**KANSAS DEPARTMENT OF TRANSPORTATION
SPECIAL PROVISION TO THE
STANDARD SPECIFICATIONS, EDITION 2015**

SECTION 835

**RESEALING JOINTS AND SEALING CRACKS IN
EXISTING PCCP AND HMA PAVEMENTS**

**FIGURE 835-2: SEALING PCCP, SPALLED JOINTS AND CRACKS
($>2" \leq 3"$ wide, $\leq 1\frac{5}{8}"$ deep)**

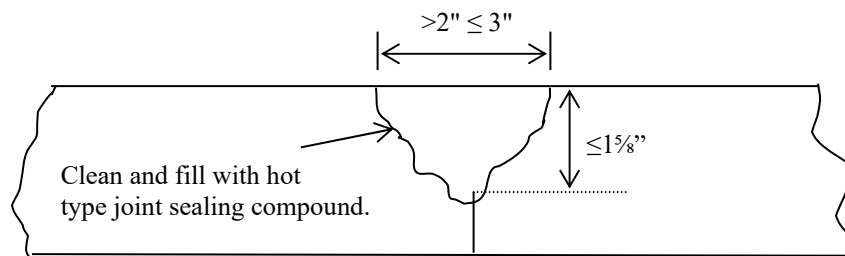
Page 800-94, replace FIGURE 835-2 with the following:

If the PCCP joints and cracks are 3 inches or less wide and 1 $\frac{5}{8}$ inches or less deep, fill the joints and cracks with hot type joint sealing compound. See **FIGURE 835-2**. Fill the joints and cracks to a level slightly recessed from the pavement surface.

**FIGURE 835-4: TYPE B, SEALING PCCP, SPALLED JOINTS AND CRACKS
($>2" \leq 3"$ wide, $>1\frac{5}{8}"$ deep)**

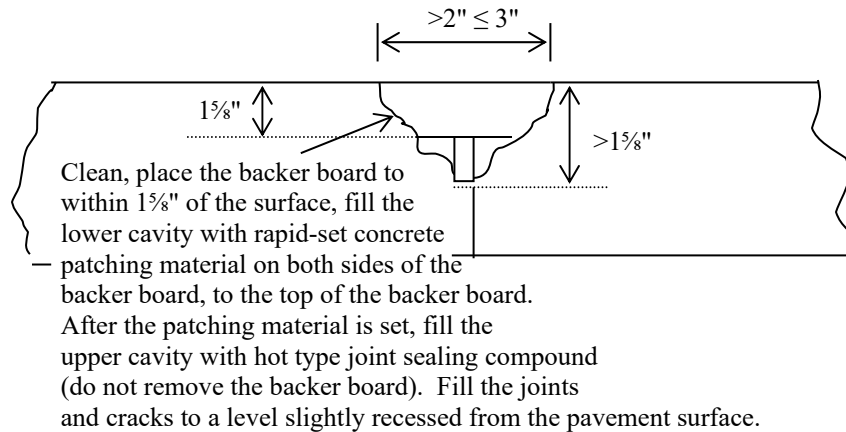
Page 800-94, replace FIGURE 835-4 with the following:

FIGURE 835-5: SEALING ASPHALT PAVEMENT CRACKS) ($>\frac{1}{8}" < 2"$)

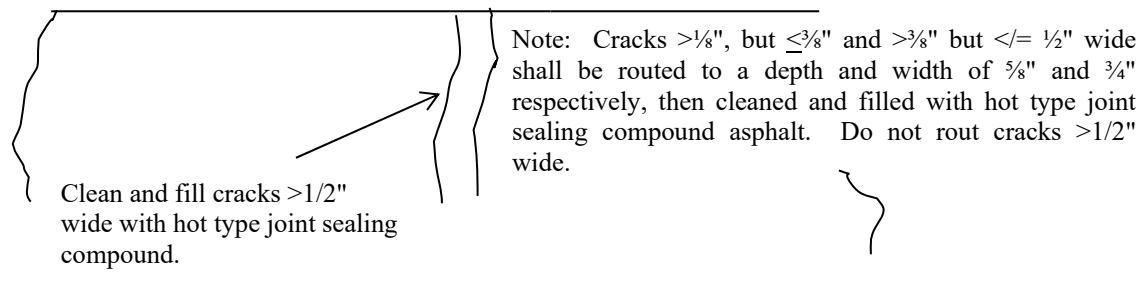
Page 800-95, replace FIGURE 835-5 with the following:

Fill the routed cracks ($\frac{1}{8}$ to $\frac{1}{2}$ inch) and the un-routed cracks (wider than $\frac{1}{2}$ inch) with hot type joint sealing compound. Fill all cracks to a level slightly recessed from the pavement surface.
